**REQUEST**

Current Zoning: R-3 (single family residential)  
Proposed Zoning: UR-2(CD) (urban residential, conditional) with five-year vested rights

Approximately 42.13 acres located on the south side of Hamilton Road, east of Steele Creek Road.  
(Council District 3 - Mayfield)

The petition proposes to construct a 206-unit townhouse community on vacant acreage in southwest Charlotte at a density of 4.9 units per acre.

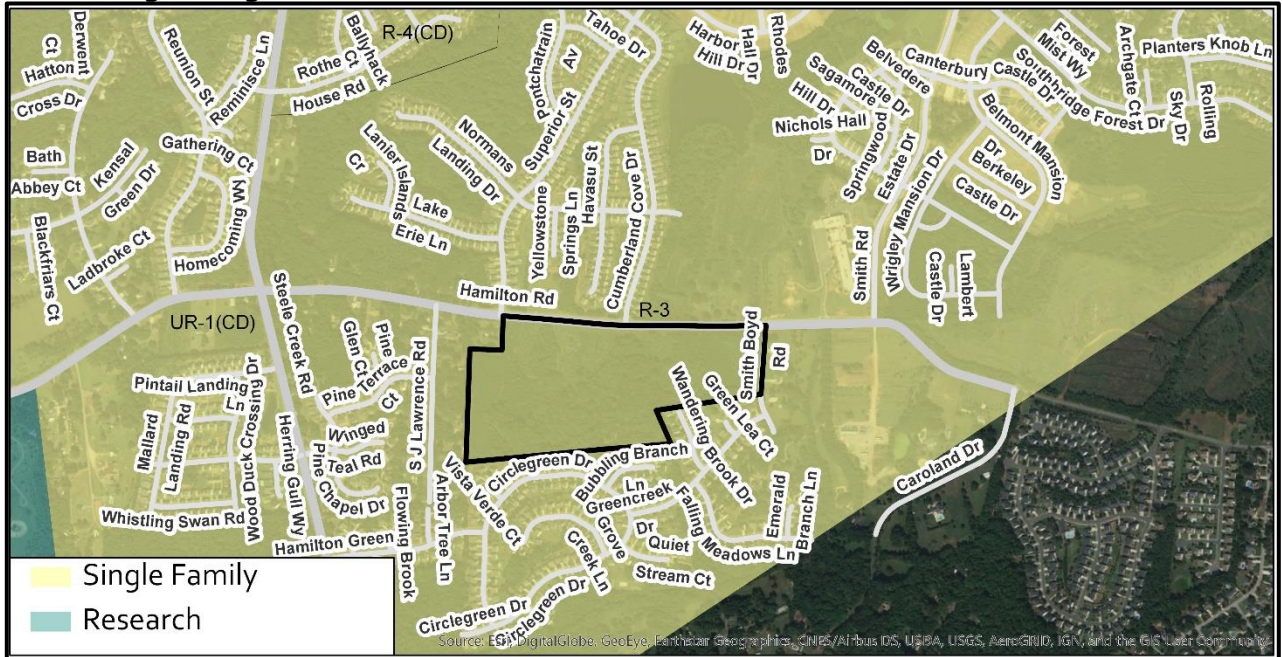
- ~~1. Show and label Potential 30-foot & 35-foot PCSO Stream Buffers per local GIS mapping data (Polaris, Charlotte Explorer, Virtual Charlotte) OR submit stream delineation report confirming buffer limits shown on rezoning plan (Please note: Stream Delineation Reports are subject to review and approval by Charlotte Storm Water Services.)~~ Addressed
- ~~2. Add the following note under an Environmental Features heading: Development within the SWIM/PCSO Buffer shall be coordinated with and subject to approval by Charlotte-Mecklenburg Storm Water Services and mitigated if required by City ordinance.~~ Addressed

- ~~3. Add a note limiting townhouse buildings to five or fewer individual units when fronting public or private network required streets.~~ Addressed
- ~~4. Add a note committing to vary the number of individual units per building in adjacent buildings.~~ Addressed
